WEST PARK DEVELOPMENT JSP15-30

Public hearing at the request of West Park Development for the approval of the Preliminary Site Plan, Wetlands Permit, Woodlands Permit and Storm water Management Plan under Roads and Utilities Construction Ordinance. The subject property is located south of Grand River Avenue and west of Beck Road in Section 17. The 31-acre property is zoned I-1, Light Industrial and the applicant is proposing to wetland fill and mitigation, construction of the Access Roadway to serve the developable parcels on the site including associated mass grading, storm water management, site utilities, Grand River Avenue access approach, berms, landscaping and emergency access connection to Providence Parkway.

PLANNING REVIEW

Review Date: July 09, 2015
Review Type: Preliminary Site Plan
Project Name: JSP15 – 0030: West Park Development
Plan Date: June 19, 2015
Prepared by: Sri Komaragiri, Planner
E-mail: skomaragiri@cityofnovi.org; **Phone:** (248) 735-5607

Figure 1 (Above). City of Novi Regulated Wetland & Woodland Map (approximate property boundary shown in red). Regulated Woodland areas are shown in green and regulated Wetland areas are shown in blue).

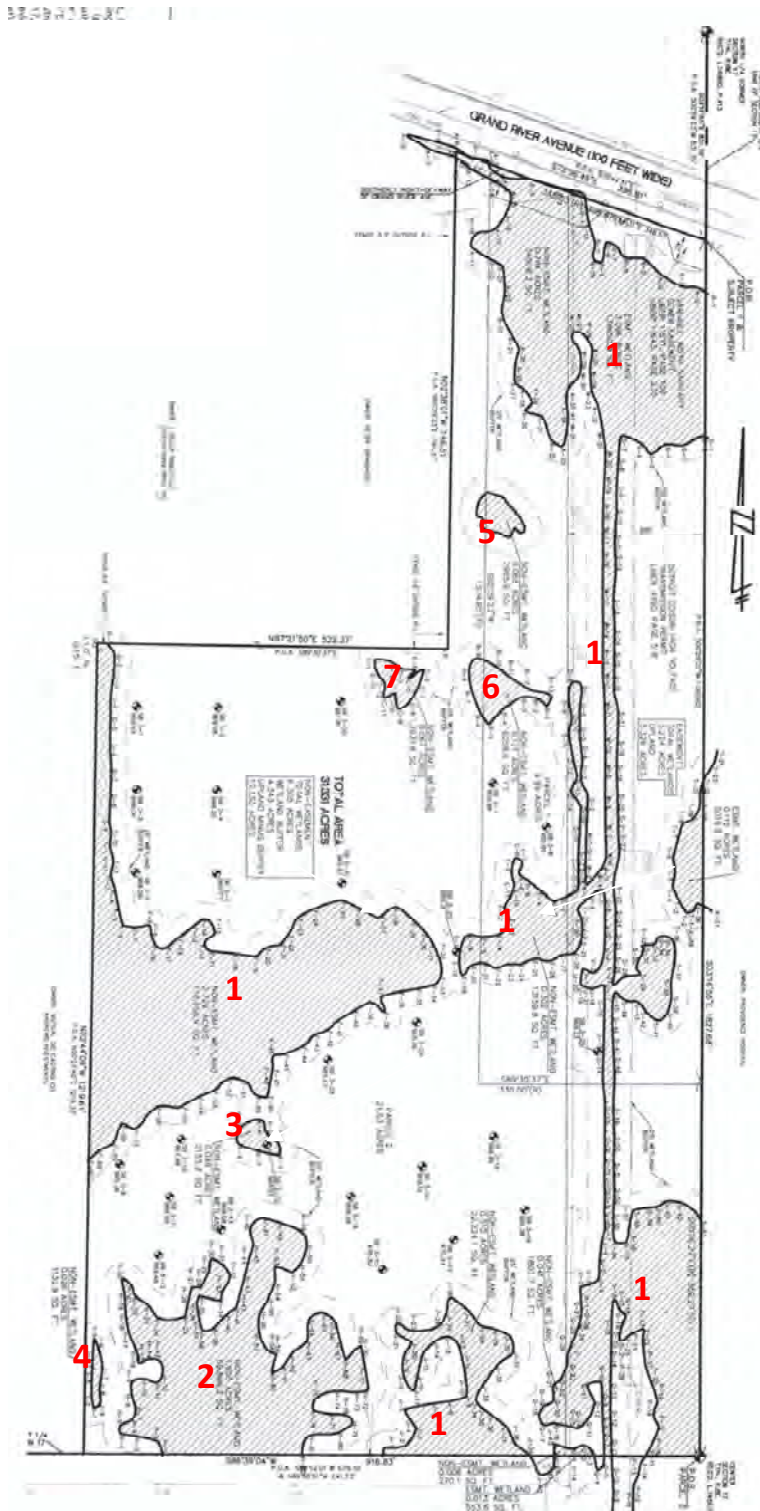
The proposed project site contains several areas of on-site wetlands. The wetland figures provided by the applicant's wetland consultant (Brooks Williamson and Associates, Inc., BWA), indicate a total of seven (7) on-site wetlands (see Figure 1, Figure 2 and Site Photos). While several of the wetlands appear to be regulated by both the City of Novi and the Michigan Department of Environmental Quality (MDEQ), a few of the wetlands (Wetland 5, 6, and 7) have previously been determined to be non-essential, and therefore not regulated by the City of Novi. These three (3) wetlands are quite small, have little storm water storage volume capacity or other essential wetland attributes.
